Addendum #3

Re: **Orchard Park Secondary School
Security Addendum 02**

TENDER ADDENDUM NO. 2

Orchard Park Secondary School Ceiling & Accessibility Renovations Hamilton Wentworth District School Board RFT-2025-133-P02090

Drawing Title
VIDEO SURVEILLANCE
SYSTEM RISER DIAGRAM

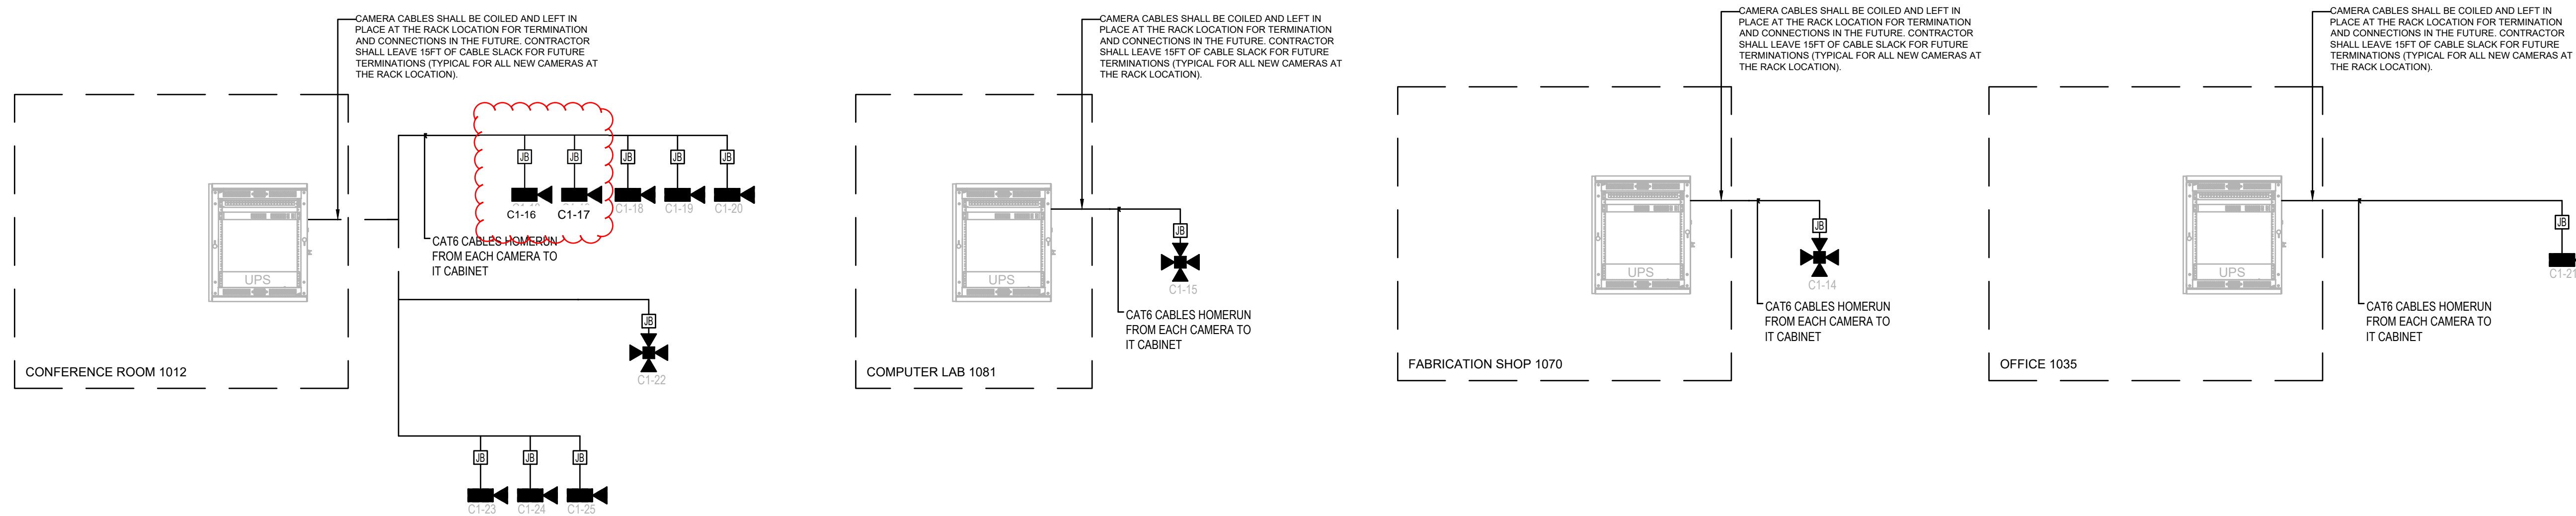
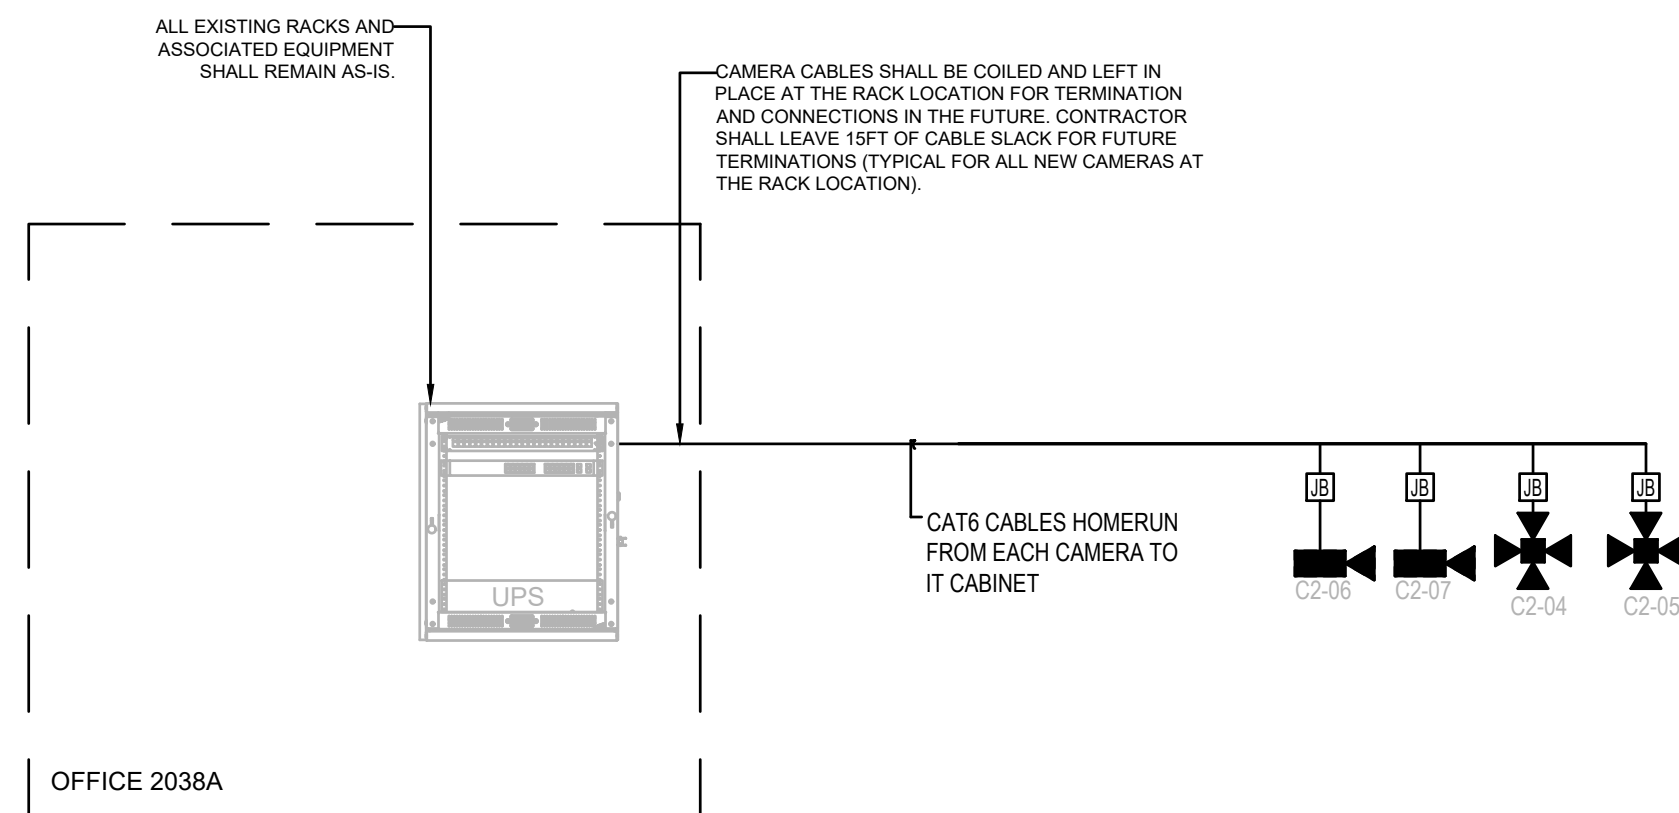
1. Discrepancy between the security drawing and security riser diagram. Cameras C1-16 and C1-17 are missing in the riser diagram, can you please advise the headend for these cameras?

[LOBO – Cameras C1-16 and C1-17 shall be routed to Existing Rack located in Conference Room 1012.](#)
